ZONING AMENDMENT,

PUD, & SUBDIVISION STAFF REPORT Date: June 1, 2006

**SUBDIVISION NAME** A & H Subdivision

**LOCATION** Southeast corner of Airport Boulevard and Hillcrest Road

## SITE PLAN

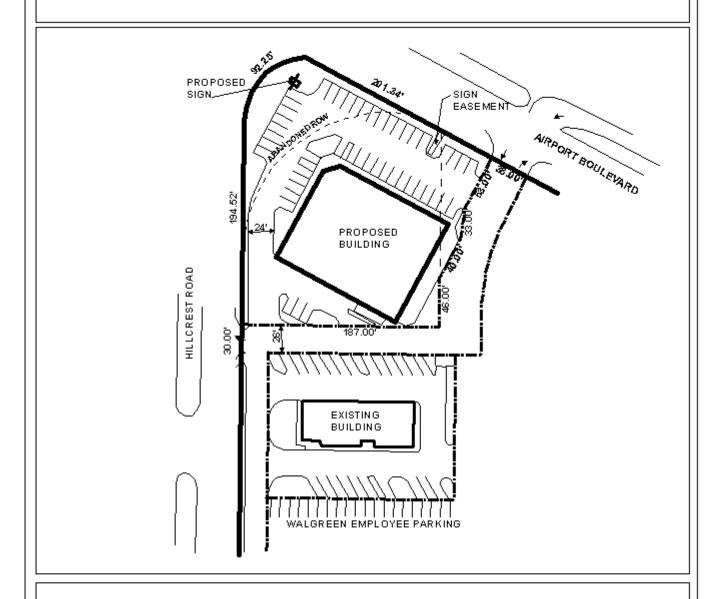
Regarding the PUD application, the applicant proposes shared access with the developed shopping center (Lot 2) and the proposed drug store (Lot 1).

Parking and circulation provisions satisfy the requirements of the Zoning Ordinance, and having shared access to two building sites appears to pose no problem. Additionally, since the site is located at the intersection of two major streets, limiting the curb cuts as illustrated on the approved Planned Unit Development should be required.

**Subdivision** The plat meets the minimum requirements of the Subdivision Regulations and is recommended for Tentative Approval with the following condition: 1) a note be placed on the final plat limiting curb cuts to the approved Planned Unit Development.
